Access Compliance Report

Public Rights-of-Way

(Curb Ramps)

| Intersection ID: 15351 | Main Street: CLANTON_RD | Cross Street: BARRINGER_DR | Location: NE |

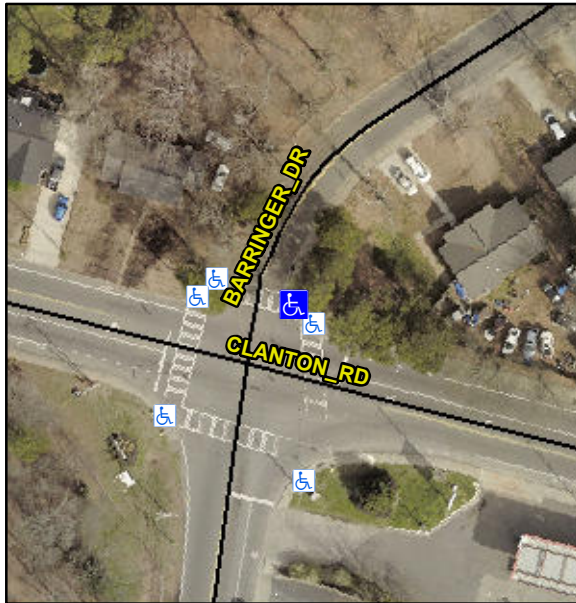
Not Found, R304.2.1, R305.2

| Compliance | Description | Data | Compliance | Description | Data |
|------------|-----------------------|--------|------------|-----------------------------|------|
| No | Landing Length (in) | 28.0 | Yes | DWS Provided? | Yes |
| N/A | Landing Curb? (Y/N) | No | No | DWS Offset (in) | 6.0 |

Remove & Replace Entire Ramp.
